Ecology and Environment, Inc.	
SCALE: 1/4" = 1'-0"	APPROVED BY: <i>[Signature]</i>
DATE: 10-20-94	DRAWN BY: <i>[Signature]</i>
CPF - PIPELINE SOIL SAMPLES	
E + E SCREENS FROM 7-9-94 - 10-19-94	DRAWING NUMBER: 01

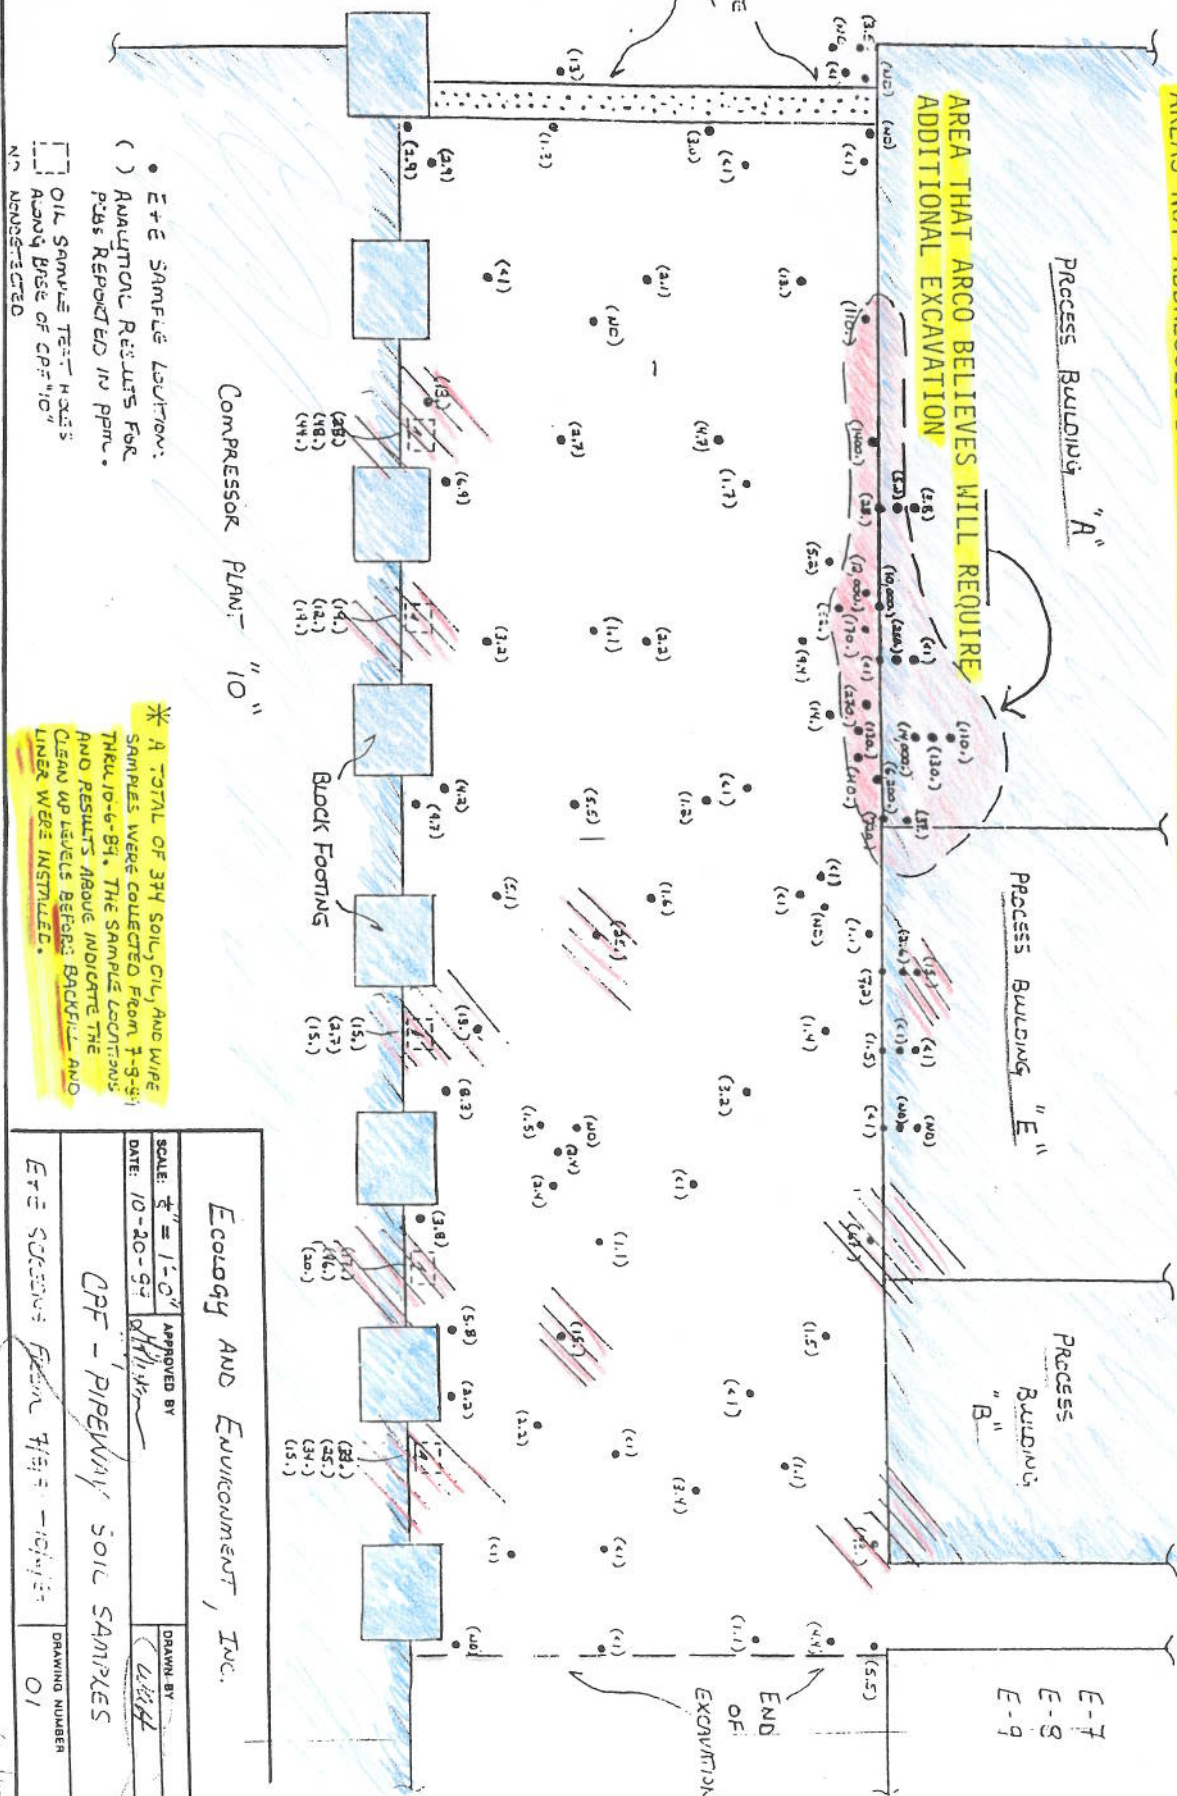
AREAS NOT ADDRESSED BY ARCO BUT MAY REQUIRE REMOVAL OF PCB

AREA THAT ARCO BELIEVES WILL REQUIRE ADDITIONAL EXCAVATION

- E + E SAMPLE LOCATION: () ANALYTICAL RESULTS FOR PCBs REPORTED IN ppm.
- OIL SAMPLE TEST HOLES ANALYSE BASE OF CPF "10" NOT MENTIONED
